Re: 6407 West Sunset Boulevard (6407-6411 West Sunset Boulevard, 1511 North Ivar Avenue, 1512 North Cahuenga Boulevard)  
Case Nos. CPC-2015-2893-VZC-HD-CUB-ZAA-SPR and ENV-2015-2895-MND  
**CF 17-0029 - Objection to Los Angeles Film School Late Submissions**

**Subject:** Hollywood Ivar Gardens  
Responses to Comments Re: Initial Construction Noise Report  
VA Project No. 6763-001

To:	Jordann Turner, City Planner Department of City Planning	Date:	August 6, 2017
From:	Clare M. Look-Jaeger, P.E. LLG Engineers <i>Clare M. Look-Jaeger</i>	LLG Ref:	1-14-4108-2
Subject:	Response to Traffic Issues Raised in the Manatt, Phelps & Phillips, LLP August 1, 2017 Comment Letter – Hollywood Ivar Gardens Hotel Project ENV-2015-2895-MND, April 2017

To:	Jordann Turner, City Planner Department of City Planning	Date:	May 24, 2017
From:	Clare M. Look-Jaeger, P.E. LLG Engineers <i>Clare M. Look-Jaeger</i>	LLG Ref:	1-14-4108-2
Subject:	Response to MRO Engineers May 11, 2017 Comment Letter – Ivar Gardens Hotel Project Traffic Impact Study

**Annotated Revised Figure 7-2  
Net New Project Traffic Volumes – Weekday PM Peak Hour**

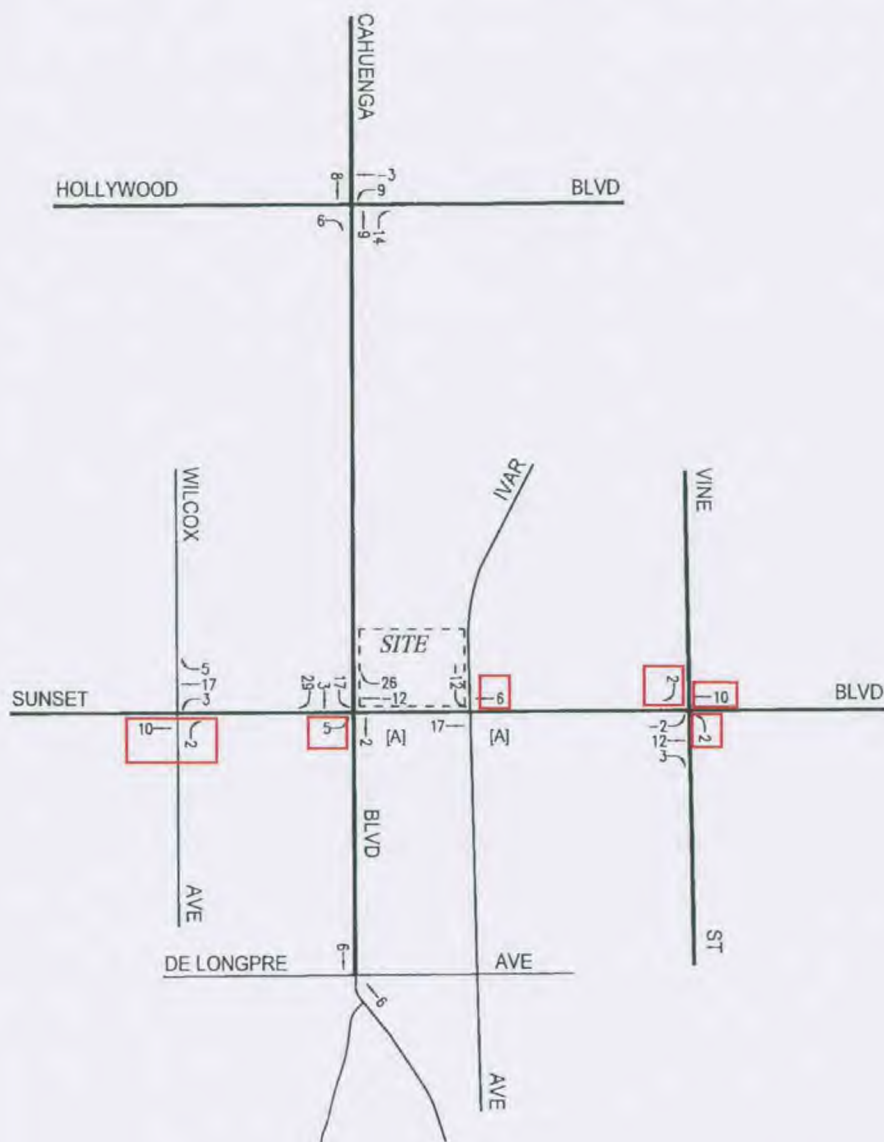
With respect to the commenter's statements regarding Figure 7-2 (Net New Project Traffic Volumes, Weekday PM Peak Hour) and the fact that the traffic volumes apparently decrease from the two further away Sunset Boulevard intersections as one approaches the project site (i.e., in the westbound direction from Vine Street towards the project site and in the eastbound direction from Wilcox Avenue towards the project site), it is apparent that the commenter does not understand that these net differences in volume reflect different distribution patterns between the existing Jack-in-the-Box fast-food restaurant and the proposed project, as well as the absence of pass-by trip reductions at the two adjacent intersections per LADOT policy. The access schemes and the total number of driveways are different between the existing use project site and the proposed project site. The commenter is referred to Appendix B of the December 23, 2015 LLG traffic impact study (Appendix G to the Mitigated

This point is illustrated by examining the revised Figure 7-2 provided in Attachment 2 to the April 2017 Response to Appeals document, and presented here as Attachment A. (Reference: Memorandum from Clare M. Look-Jaeger, Linscott, Law & Greenspan, to Jordann Turner, Department of City Planning, "Response to Public Comments – Ivar Gardens Hotel Project Traffic Impact Study," September 26, 2016.) As shown on that figure, a total of 12 "net new" trips are shown to be exiting the Sunset Boulevard/Wilcox Avenue intersection and heading eastbound toward the project site (10 eastbound through vehicles and 2 northbound right turns). However, on the eastbound approach at Sunset Boulevard/Cahuenga Boulevard, only 5 new trips are shown. Where did the other 5 trips go? It is simply illogical to suggest that the volume of project-related traffic is lower adjacent to the project site than it is farther from the site.

Negative Declaration [MND]), which contains Appendix Figure B-1 (Existing Site Distribution, AM Peak Hour), Appendix Figure B-2 (Existing Site Distribution, PM Peak Hour), Appendix Figure B-3 (Proposed Project Site Distribution, AM Peak Hour), and Appendix Figure B-4 (Proposed Project Site Distribution, PM Peak Hour). Therefore, for these reasons, the net differences in traffic volume between intersections (i.e., the traffic volume leaving one intersection and arriving at the next, e.g., in the westbound direction from Vine Street towards the project site and in the eastbound direction from Wilcox Avenue towards the project site) will not be the same. Thus, there is no apparent “loss” of eastbound and westbound traffic approaching the proposed project site and the traffic study assignment documented in the LLG study is not erroneous as referenced by the commenter. No further analysis is therefore warranted or required.

# Fast-Food Restaurant with Drive-Through Window (934)

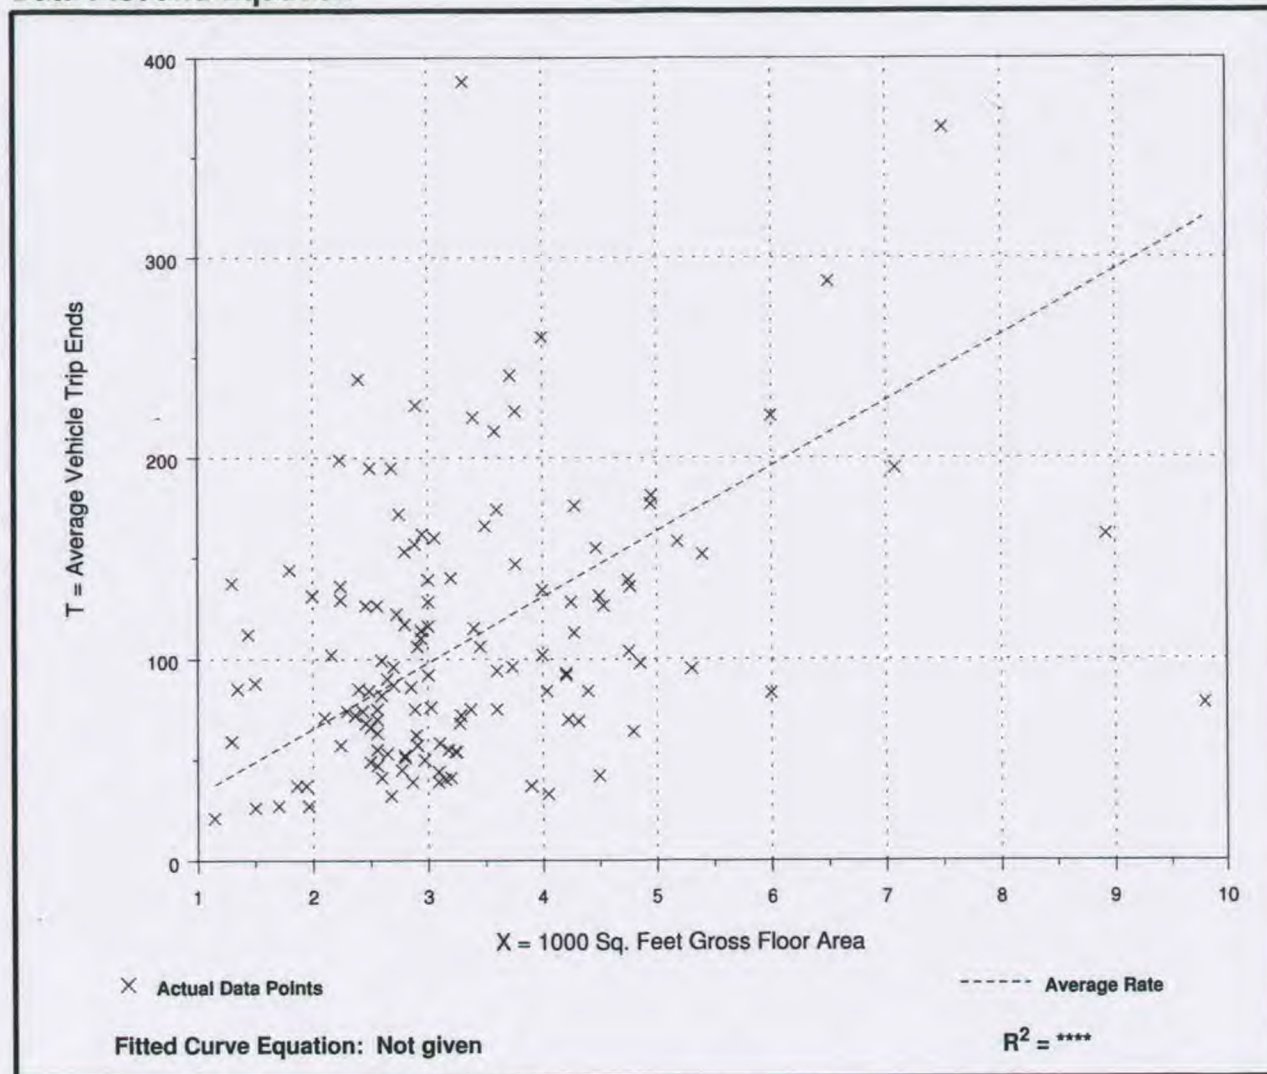
3. ***Existing Jack in the Box Traffic*** – We commented that the use of standard ITE trip generation rates to estimate the volume of peak-hour traffic associated with the existing Jack in the Box restaurant was inappropriate, and that the preferable approach would be to perform actual counts of traffic at the restaurant's driveways. Only then can we be assured that the estimate of "net new trips" associated with the proposed project is accurate. According to Response to Comment 1C.6 (p. 41), "... LADOT did not require site specific traffic counts in order to determine the existing land use trip generation credit," purportedly because the land use is not atypical and is well represented in the ITE database.

Response No. 3 - Existing Jack-in-the Box Restaurant Traffic: For purposes of assessing project-related traffic impacts and pass-by trip reductions at non-adjacent intersections, LADOT traffic study guidelines do allow the incorporation of existing-use trip generation credits (i.e., the existing trip generation credit for the Jack-in-the-Box fast-food restaurant which will be demolished as part of the proposed project).

# TRUCK MANEUVERING ANALYSIS

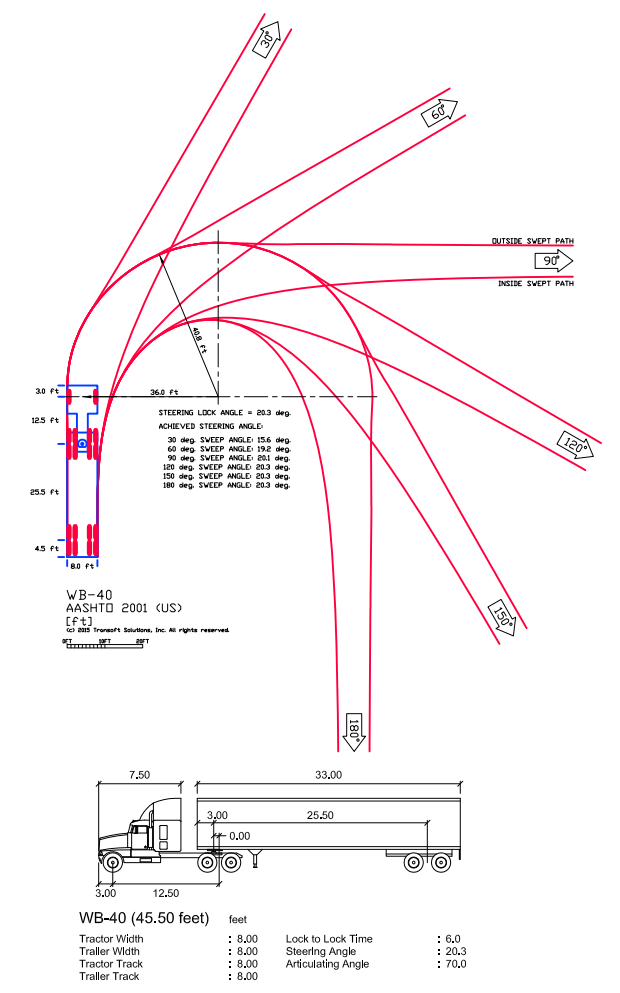
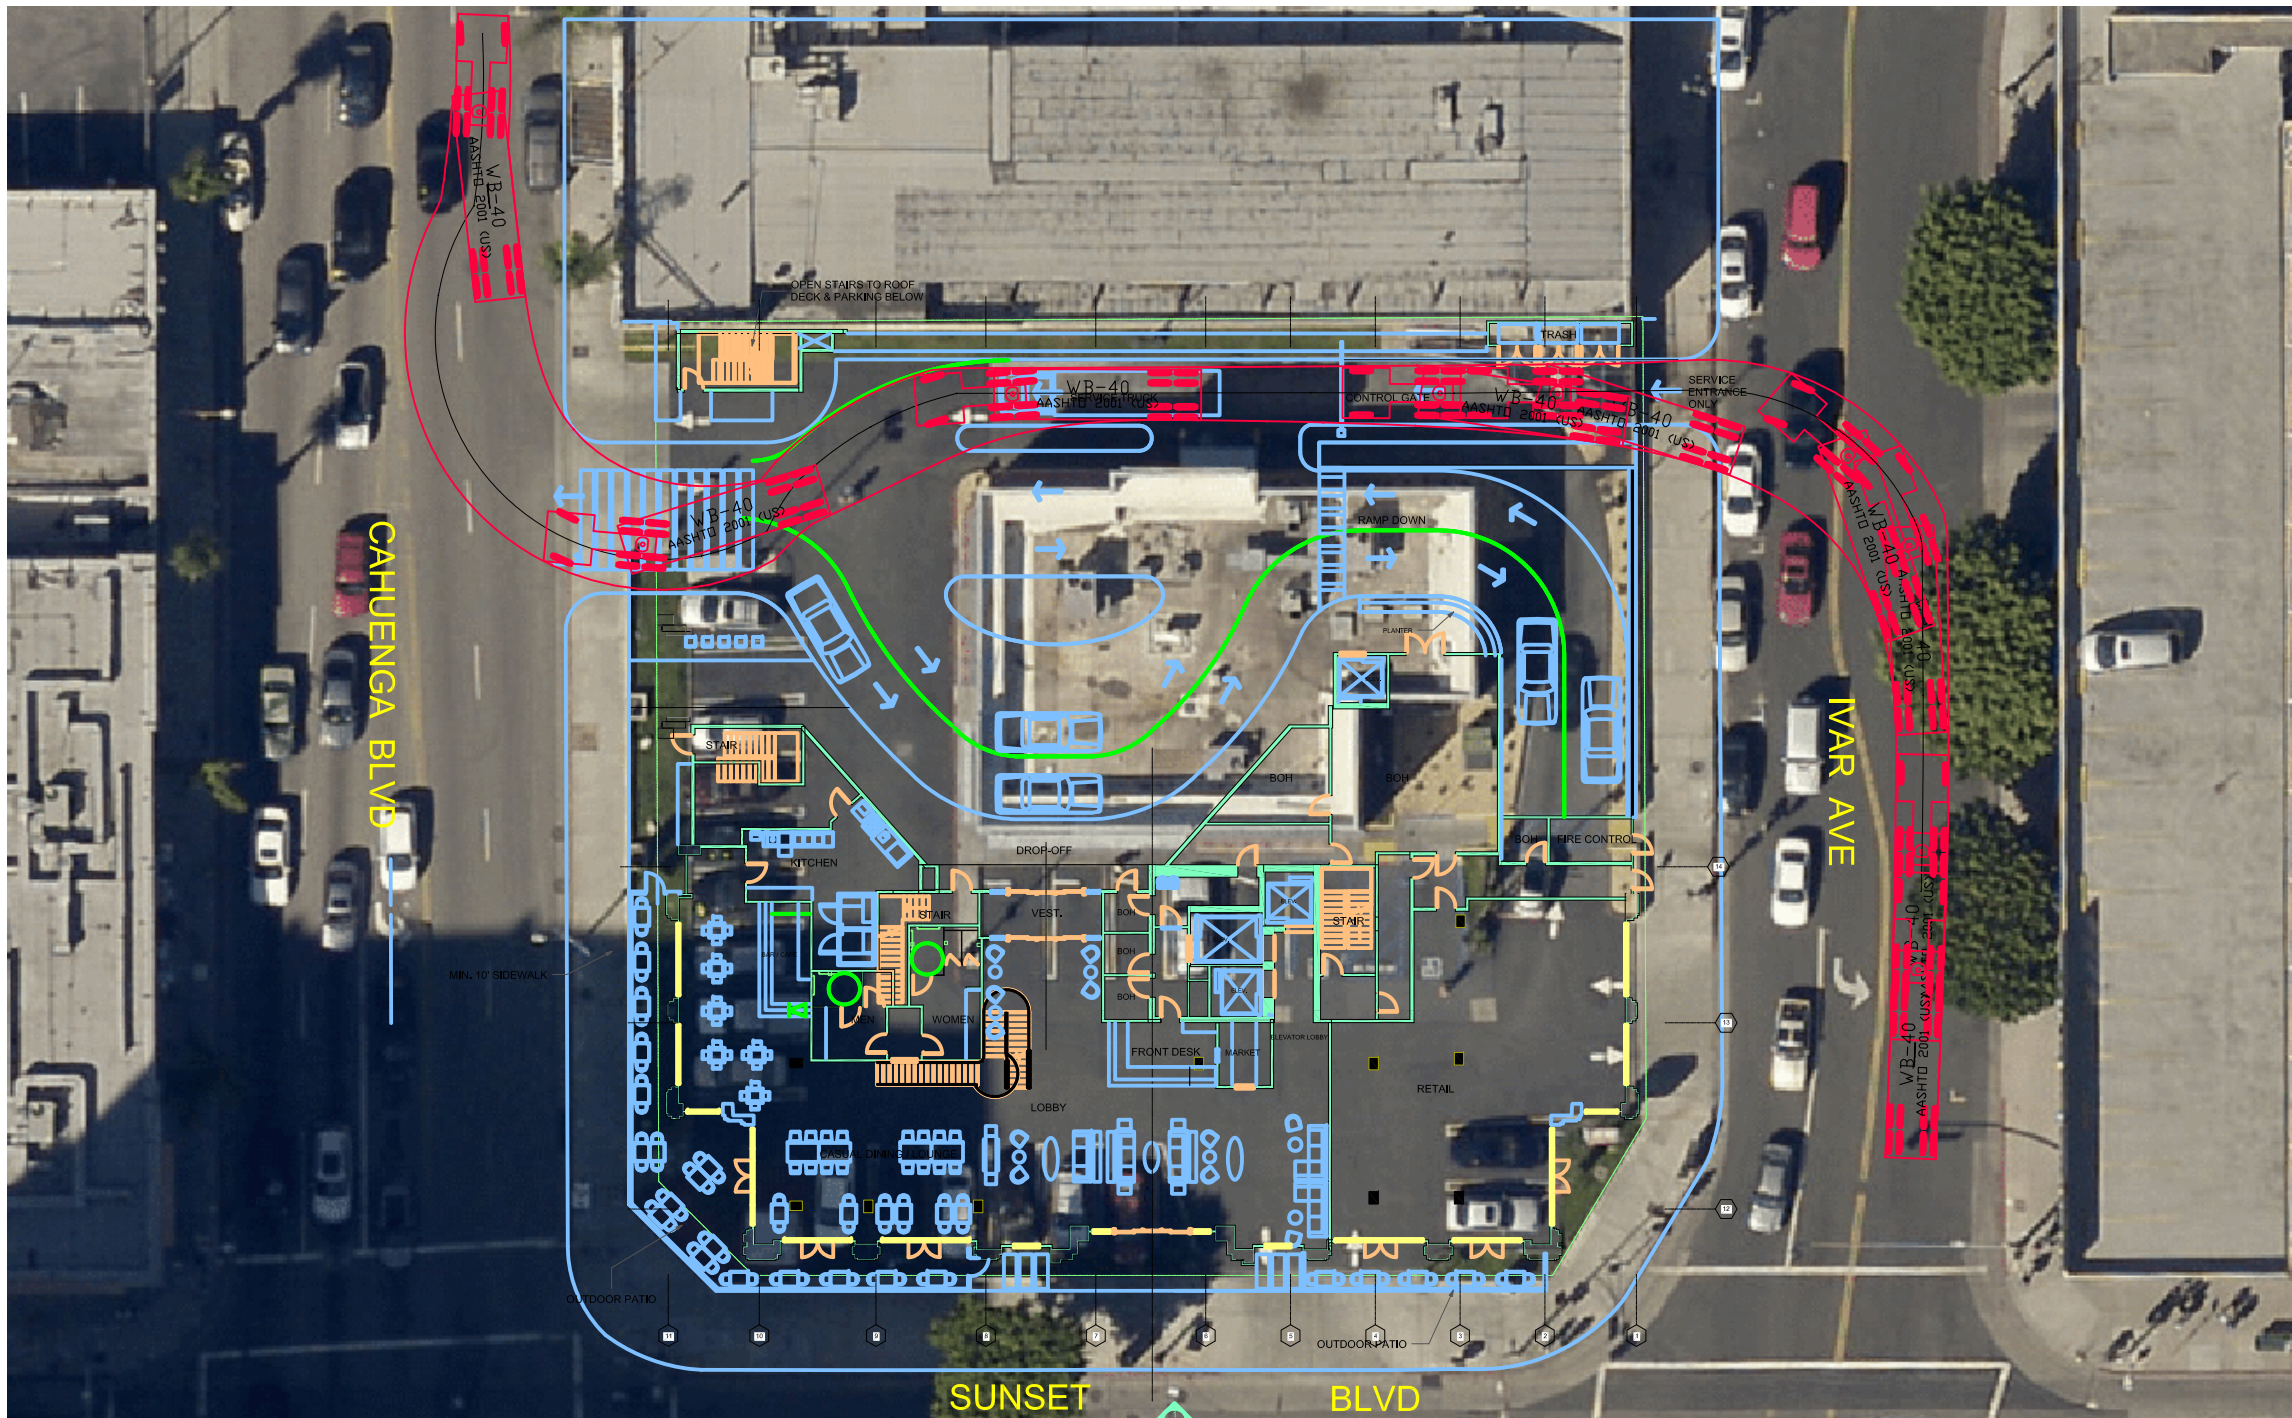
- Comment 1C.8: Will drivers be able to safely make left turns into and out of the site at the Cahuenga Boulevard driveway? This is a particular issue for exiting trucks.

→ Again, the truck maneuvering studies were not provided for public review and comment. The fact that the roadway striping allows left turns to be made provides no assurance that such turns can be made safely.

As noted in Response No. 4A above, truck maneuvering studies were performed to demonstrate the feasibility of the service driveway and design to accommodate service vehicles. While the existing roadway striping on Cahuenga Boulevard does allow for left-turns in and left-turns out, service truck maneuvering studies were performed for the more constrained exiting right-turn maneuver (onto northbound Cahuenga Boulevard). Refer to Response No. 4A for a full discussion regarding the supplemental information regarding service deliveries and analysis of the Cahuenga Boulevard driveway.

Response: Truck maneuvering studies were performed to demonstrate the feasibility of the service driveway and design to accommodate service vehicles, and additional maneuvering studies also were performed for the exiting maneuver. The existing roadway striping on Cahuenga Boulevard allows for left-turns in and left-turns out.
